Service Bulletins 1976-1978

**Rolls-Royce Silver Shadow,
Long Wheelbase,
Corniche and Camargue
Bentley T Series and Corniche
Rolls-Royce Silver Shadow II
and Silver Wraith II
Bentley T2**

TSD 4171

Service Bulletin Index for T.S.D. 4171

Figure 4 - Fitting Relay to Right-Hand Inner Wing

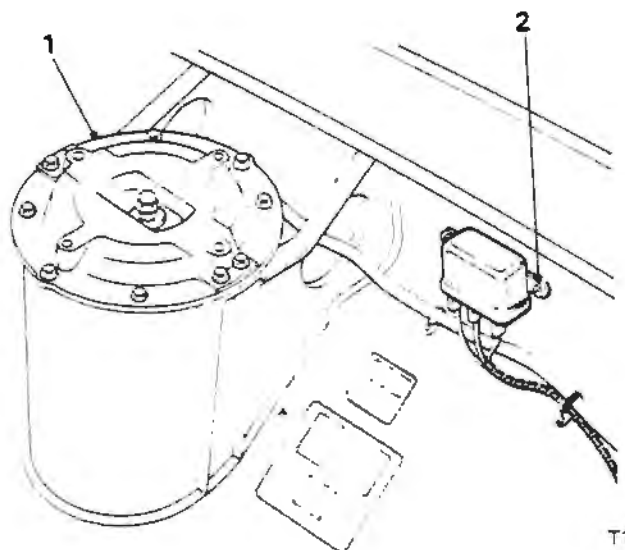
NOTE: For Corniche and Camargue cars fit the UD 9270 relay to the right-hand inner wing as shown in Figure 4, utilising the self-tapping screws and washers provided.

Figure 9 - Gearbox Connection and Blanking Plug to be Changed and Removed

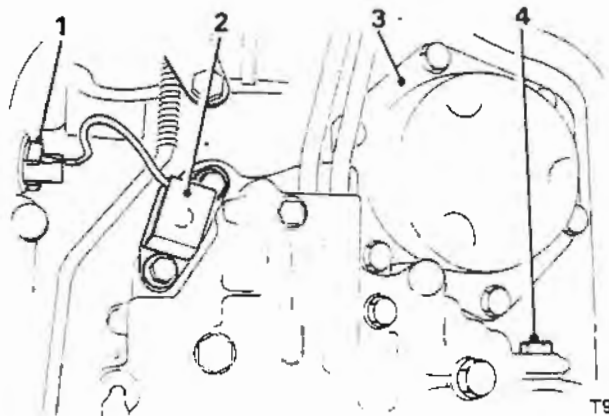
- 1 Drain the gearbox fluid and remove the gearbox sump and filter as described in Chapter T - Part 2 of Workshop Manual T.S.D. 2476.
- 2 Remove the pressure switch blanking plug shown in Figure 9 and screw in the top gear pressure switch GM 6462286 supplied.

FIGURE 1

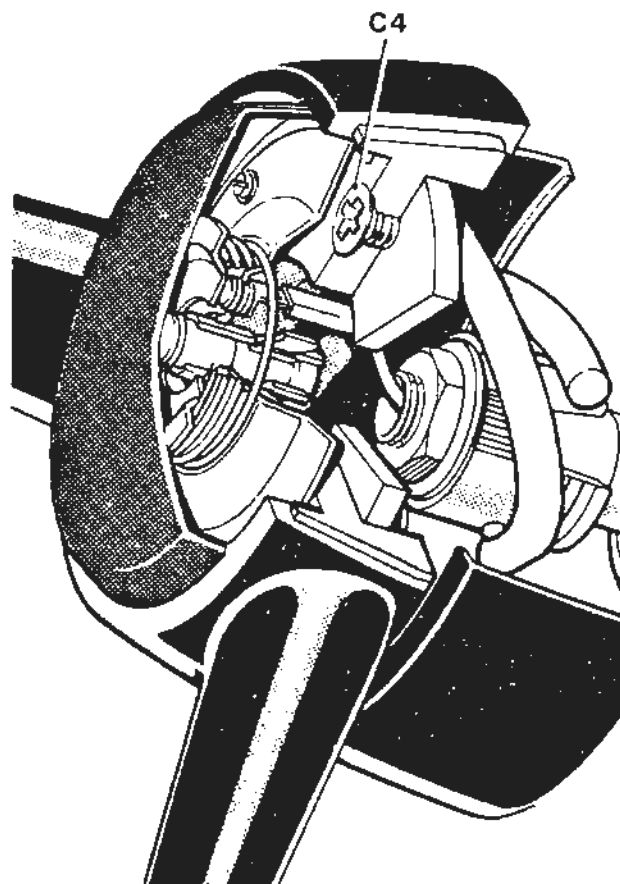
1. Raise the car on a hoist.
2. Check the torque of the four setscrews shown in Figure 1, item C1. The correct figures are 5,8 kg.m. to 6,2 kg.m. (42 lb.ft. to 45 lb.ft.) and the check should be made using a 5/8 in. A/F socket and universal joint, extension bar and normal torque spanner.

1. Raise the car on the hoist.
2. Check the torque of the four nuts and bolts shown in Figure 1 item C2 using a normal torque spanner and socket, and raise to the revised torque figure if necessary.

2. Visually inspect the two setscrews securing the inner ball joint bracket to the steering rack as shown in Figure 1, item C3. The setscrews should carry the wording "GKN M 8.8". If the wording is incorrect then the setscrews must be renewed as follows.
3. Knock back the locking tabs.
4. Unscrew and remove the incorrectly worded setscrews.
5. Fit new setscrews part number SPM 1278 and new lock plate SPM 1279.
6. The setscrews should be torque tightened to 3,8 kg.m. to 4,1 kg.m. (27.5 lb.ft. to 30 lb.ft.) and the lock tabs correctly turned over.
7. Any incorrectly worded setscrews should be returned to R-RM on a service label quoting this Service Bulletin number.

Figure 2 - TRACK ROD ADJUSTER CLAMP BOLT

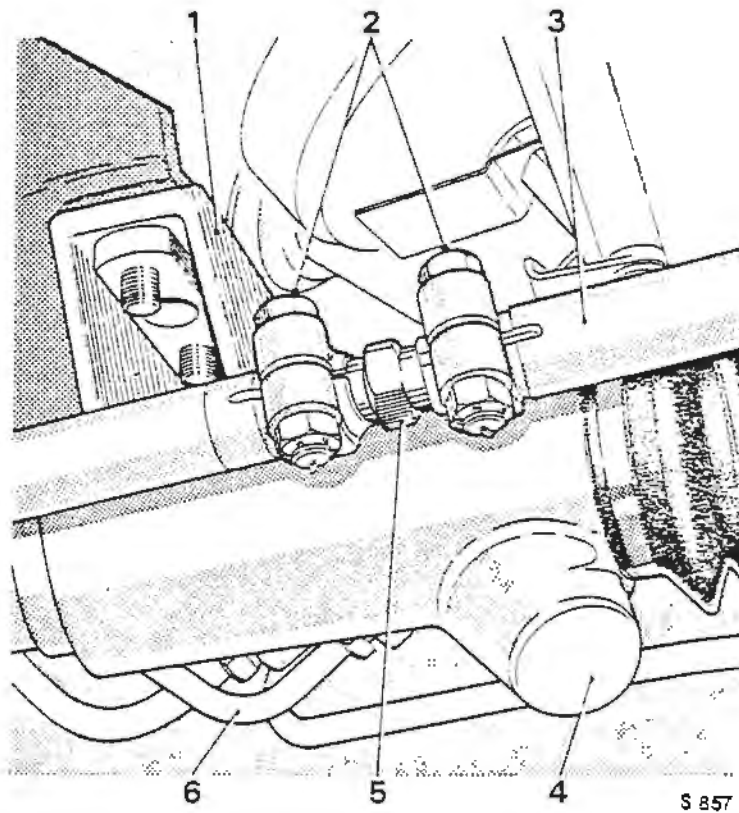
The track rod adjusting clamp bolts should be tightened to 2,2 Kgf m (16 lbf ft). When tightening the nut, if the split pin hole is not aligned correctly then the nut should be tightened further only to the next castellation to allow the split pin to be fitted and secured.
